This brochure compromises of the proposed design changes to Block A and Phase 1A, which are submitted as a non material amendment to Reading Borough Council.

Block A forms part of a much wider scheme relating to the redevelopment of the St MartIn's Precinct in Caversham which was granted planning permission on 31 March 2015 with Reference No.140997. Block A was redesignated as Phase 1A in a Deed of Variation to the S106 agreement dated 20 April 2017.

3.0 Proposed revised design comparison

Proposed phase 1A site plan

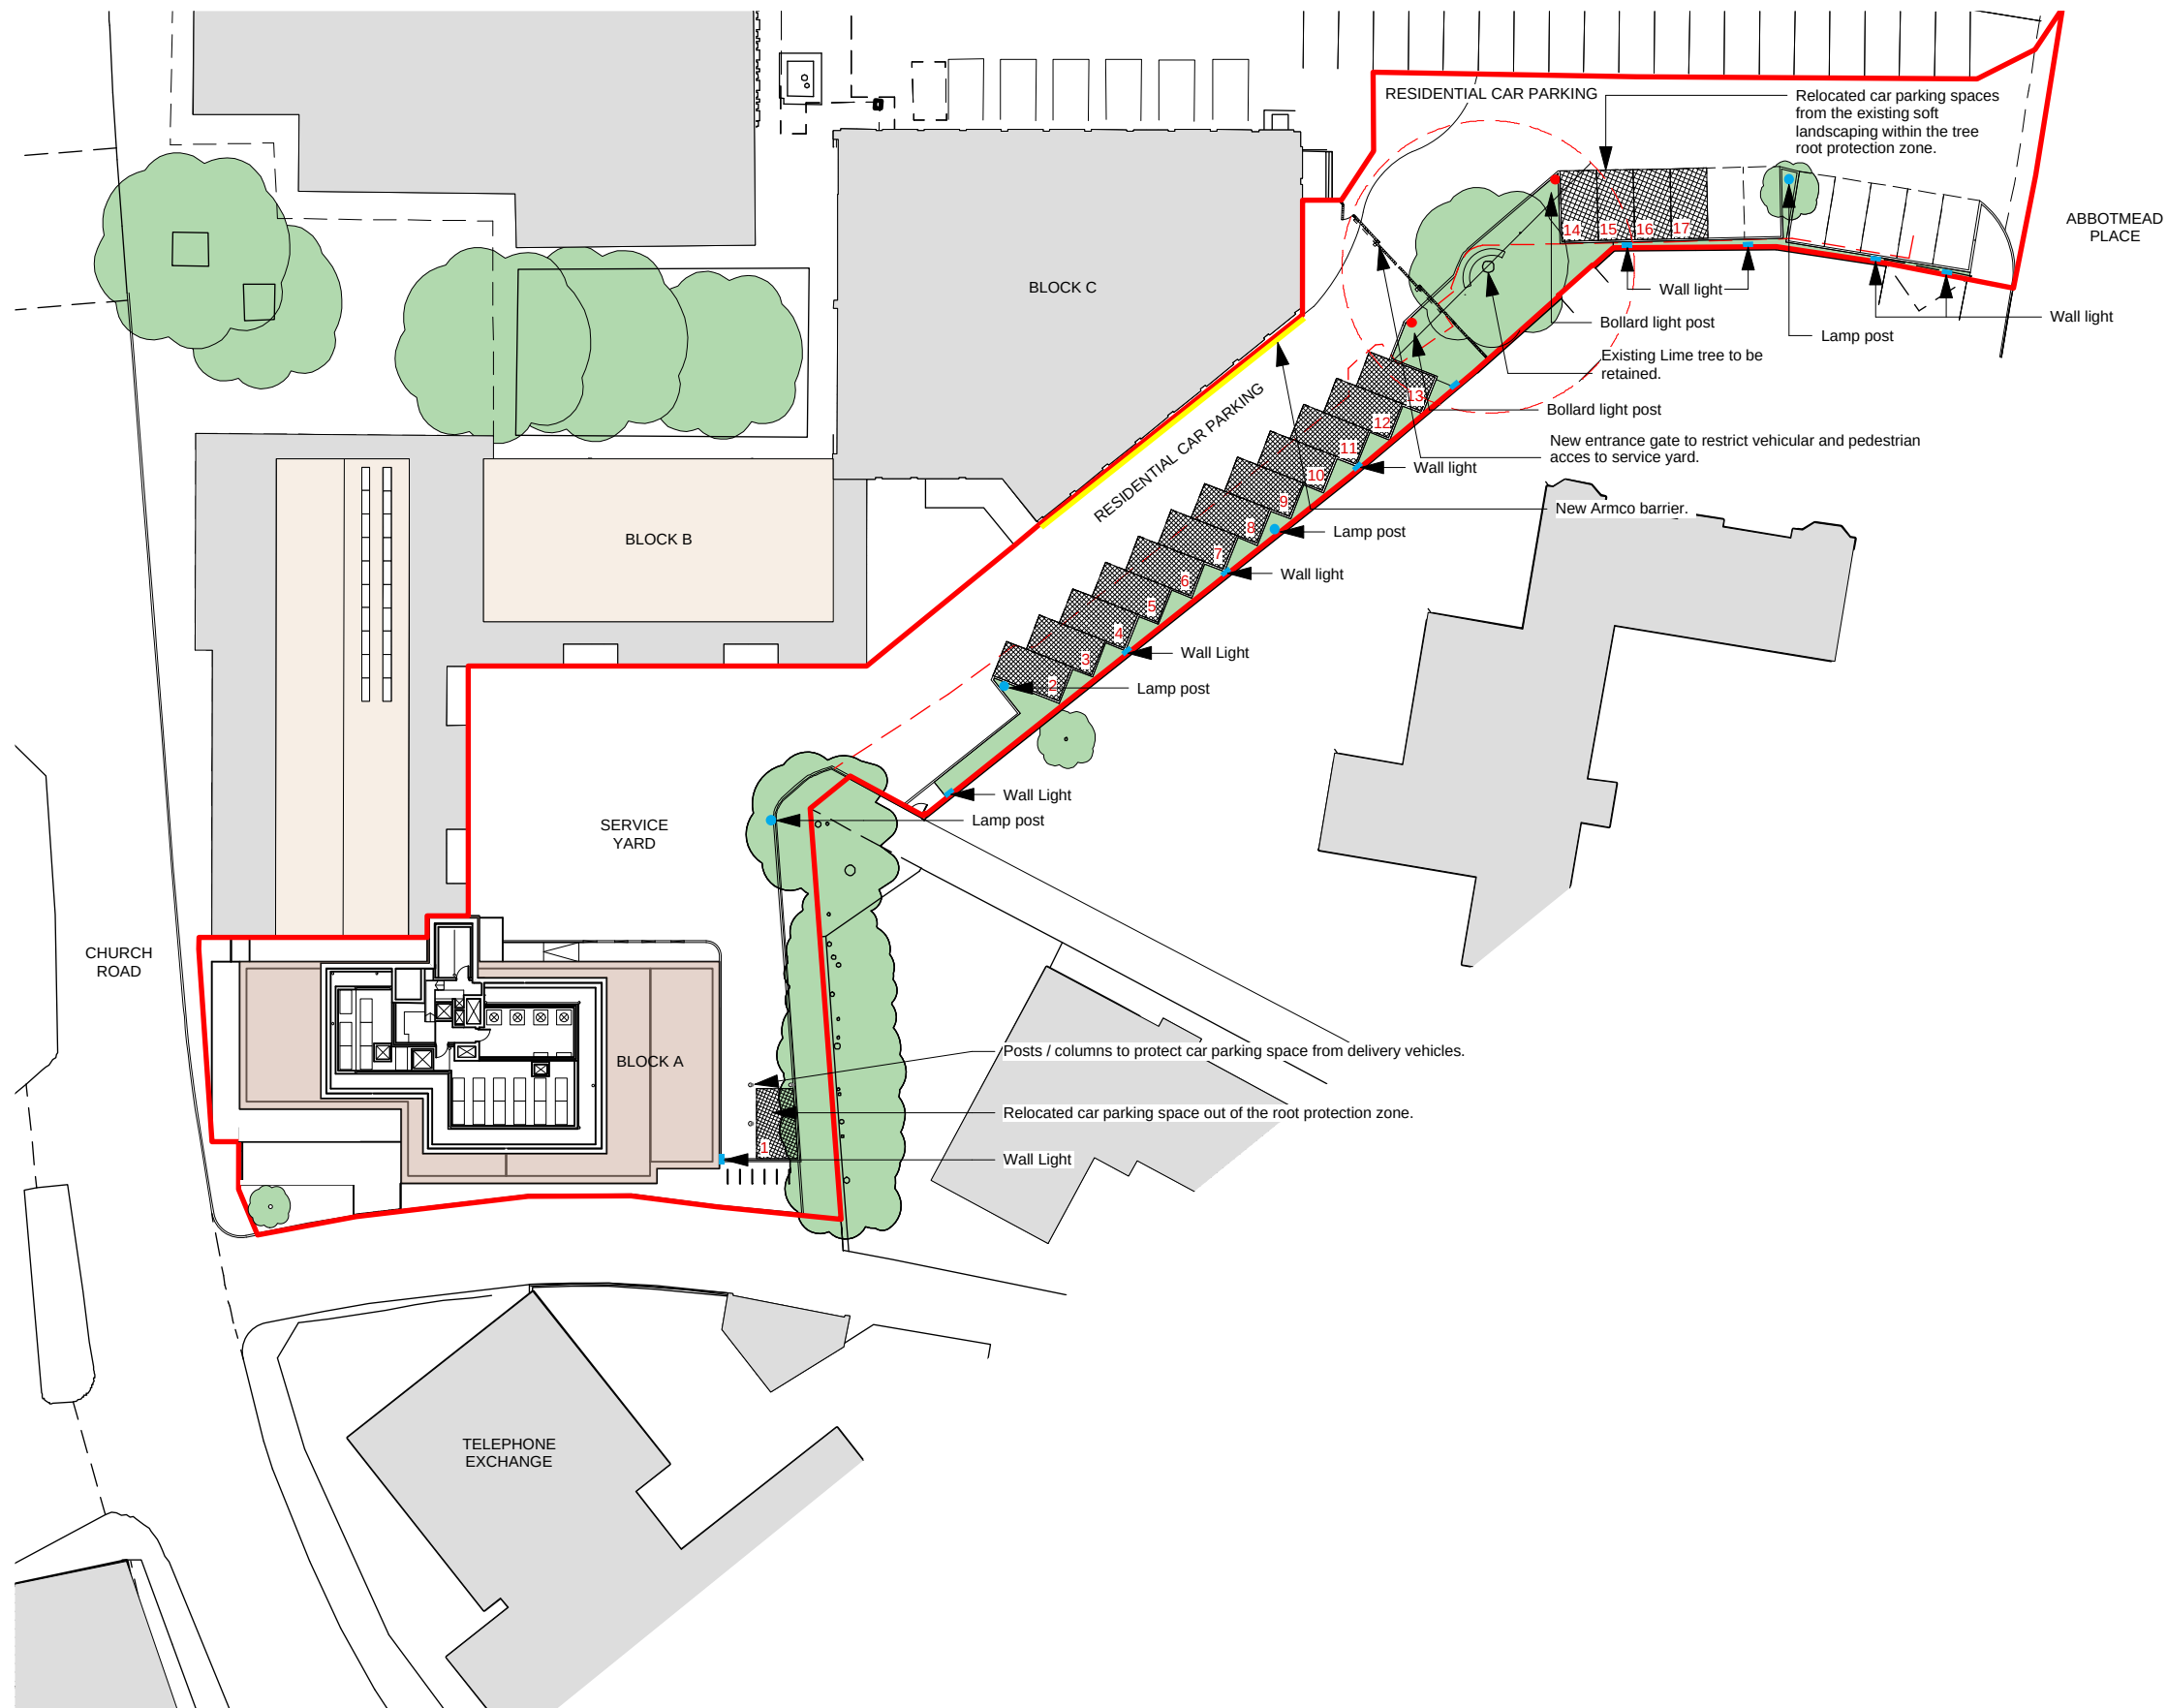
In order to bring forward phase 1A in advance of the balance of the development, an amendment is required to the phasing plan contained in the 2017 Deed of Variation. For reasons of construction practicality, it is proposed to slightly increase the area of the phase at the rear of the site to include the access road and bellmouth with Abbotmead Place. This will still permit operation of the balance of the St Martin's Centre car park and service access to the rear of the Iceland store and other retail units will be coordinated as part of the main contractor's responsibility.

Ground floor configuration

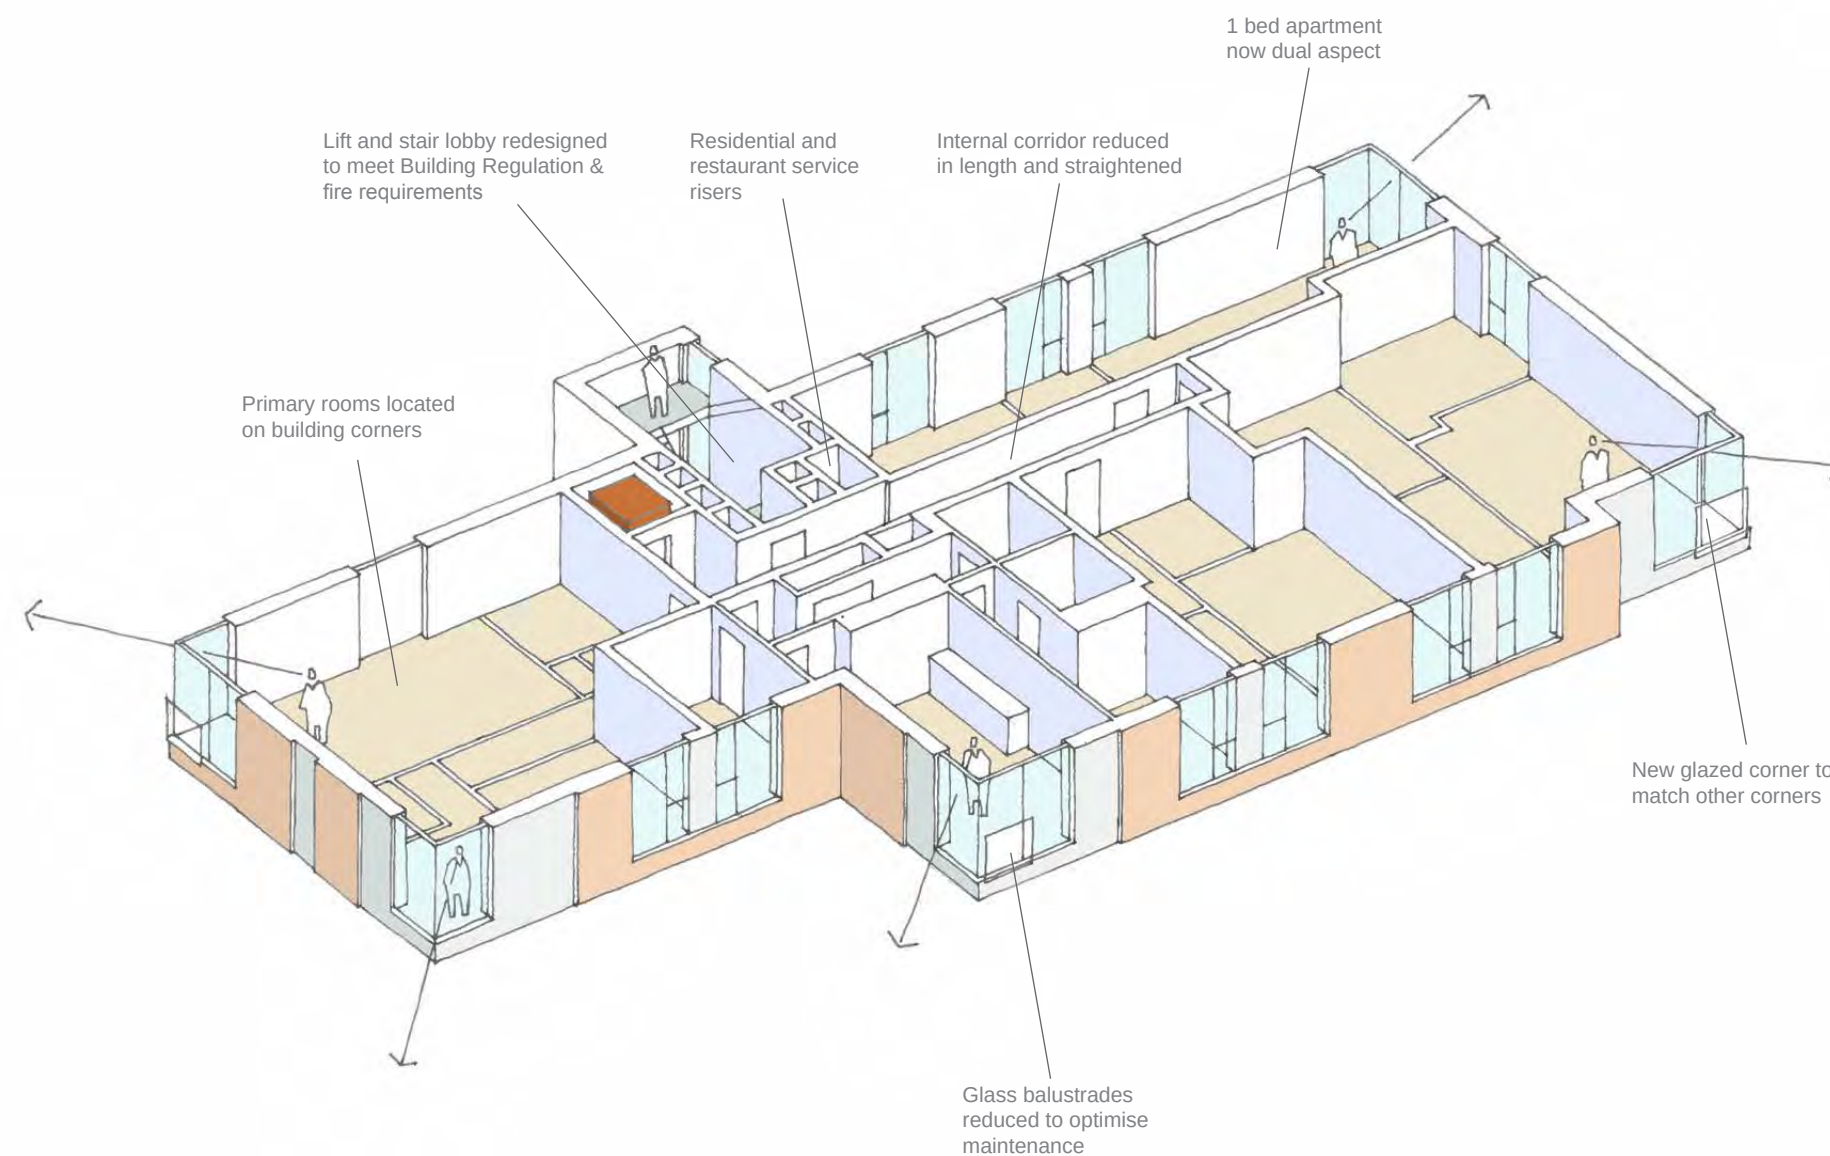
The primary change to the approved scheme at ground floor level is the infilling of the previously proposed undercroft to the rear of the building and the relocation of 3 car parking spaces in order to incorporate the necessary provision of ancillary requirements needed to ensure both the residential and commercial elements can function properly. 1 of the spaces has been located to the south of the building and the 2 other spaces form part of a considered car parking scheme for the residential block that extends to Abbotsmead Place and includes proposed secure pedestrian and vehicular gates at the rear of Block C.

A secure internal cycle store accommodating 24 spaces is provided for residents conveniently located adjacent to the residential rear entrance, together with a dedicated residential refuse store, both of which are sized to accommodate the necessary number of cycles and bins respectively to meet RBC requirements. Travel distances from the apartments to the refuse store and also from the refuse store to the loading area where the refuse lorry will park are all to the relevant standards.

The main entrance to the residential accommodation has been enhanced internally with a enlarged hallway that accommodates the postboxes for the apartments. A double lobby has been incorporated to meet secure by design standards.

The basic configuration of the restaurant has been retained with provision made for secure refuse storage and gas intake room. Provision for ventilation louvres has been discreetly made in the clerestorey glazing to the west and south elevations. As with the residential element, a dedicated commercial refuse store has been provided to its rear that is easily accessible from the "back of house" service entrance.

Typical residential floor

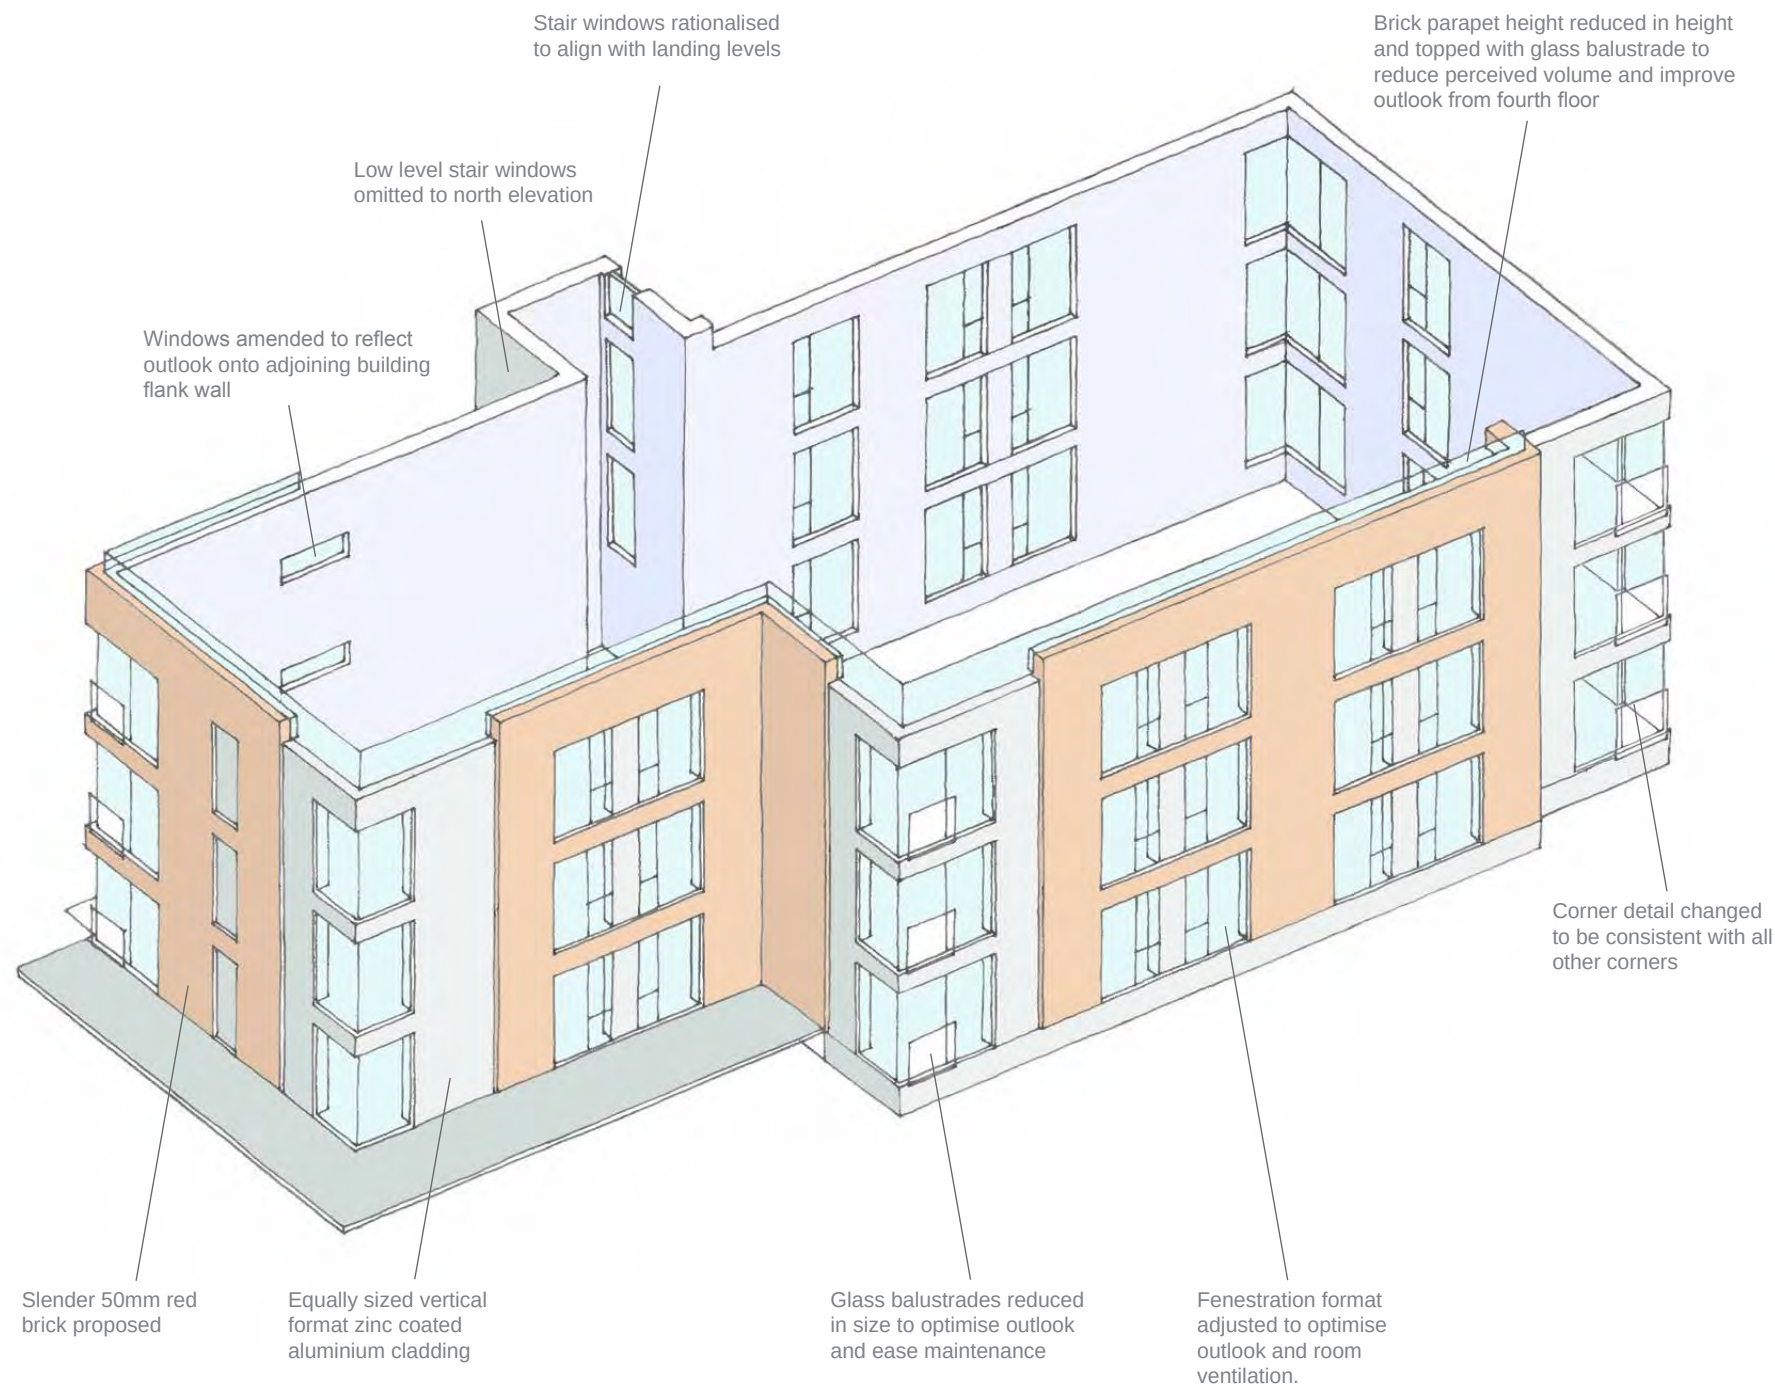
The layouts of the typical residential floors have been amended to optimise the living arrangements of the apartments, eliminate extended corridors both in the common parts and within the apartments, and provide the required services risers essential to the technical operation of the building.

The stair core has been planned in detail to provide a dry riser outlet, a passive smoke exhaust shaft, water services riser, electrical riser, boiler flue and gas riser in addition to a flue enclosure and refrigeration pipework riser to roof level serving the restaurant unit.

The apartments have been reconfigured to improve the previously single aspect 1 bed apartment overlooking the service yard so that it is now dual aspect with a southerly facing living room. The other apartments have been amended to optimise the outlook from the primary rooms and locate apartments appropriately. A glazed corner is proposed to the south-west corner of the building to be consistent with the overall architectural approach.

Internally the apartments have been planned in detail to ensure that they are Lifetimes Homes compliant and meet the minimum sizes of the technical housing standards, nationally described space standard. This has entailed detailed planning to ensure consistent bathroom, kitchen and wardrobe provision. Aspect and receipt of natural light has been maximised to all apartments and habitable rooms.
